Work Order ID 95447

Item Name: Crosstube Assembly, Mid Fwd

DRAWING NO. D206-667-147
SHEET 1 OF 4

DRAWING NO. D206-667-147	TITLE CROSSTUBE ASS'Y (206L MID FWD)	REV. A	DART AEROSPACE LTD ENGINEERING ORDER		D.E.O. NO. D206-667-147-A-1	SHEET NO. SHEET 1 OF 1	SCALE NTS
DRAWN 9P	CHECKED A.S.S.	MFG. APPR. [Signature]	APPROVED [Signature]		DE APPR. [Signature]		
DATE 11.07.15	DATE 11.07.20	DATE 11.07.21	DATE 11/07/21		DATE 11.07.21

DETAIL P
BONDING STRAP INSTALLATION 2 PL

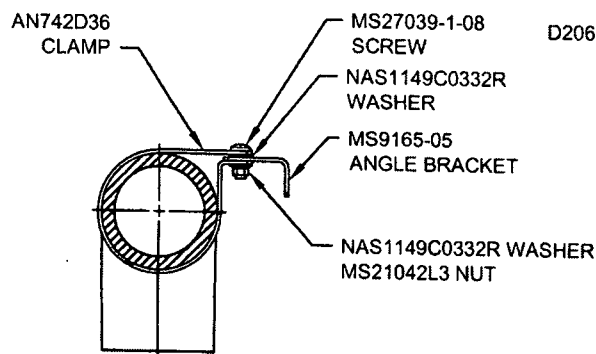
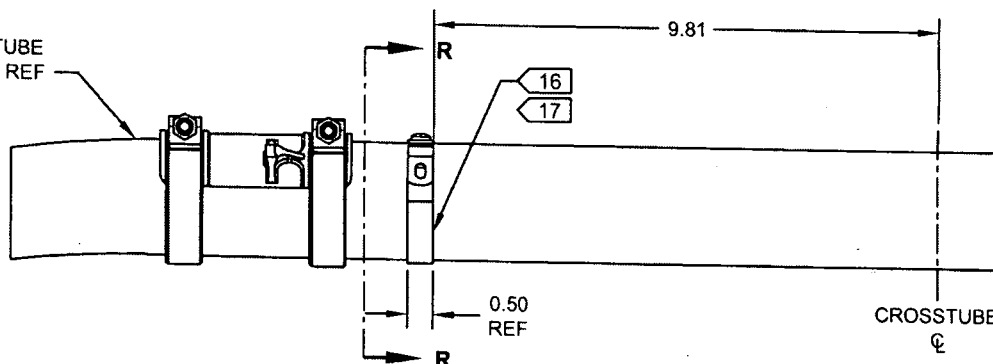
ADD ELECTRICAL GROUNDING STRAP

ADD

ADD

ITEM	QTY -147	PART NUMBER	DESCRIPTION
1	X	D206-667-147	CROSSTUBE ASSEMBLY (206L MID FWD)
10	2	AN742D36	CLAMP
11	2	MS9165-05	ANGLE BRACKET
12	2	MS21042L3	NUT (OR MS21042-3)
13	2	MS27039-1-08	SCREW
14	4	NAS1149C0332R	WASHER (OR AN960C10L)

- 16) MASK AREA UNDER CLAMP PRIOR TO PAINTING
- 17) SEAL EDGES WHERE AN742D36 CLAMP MEETS WITH THE CROSSTUBE USING SIKAFLEX-241/291 OR MIL-S-8802 CLASS B2 OR PROSEAL 890 SEALANT
- 18) PERFORM RESISTANCE CHECK TO ENSURE MAX RESISTANCE IS 10 MILLIOHMS
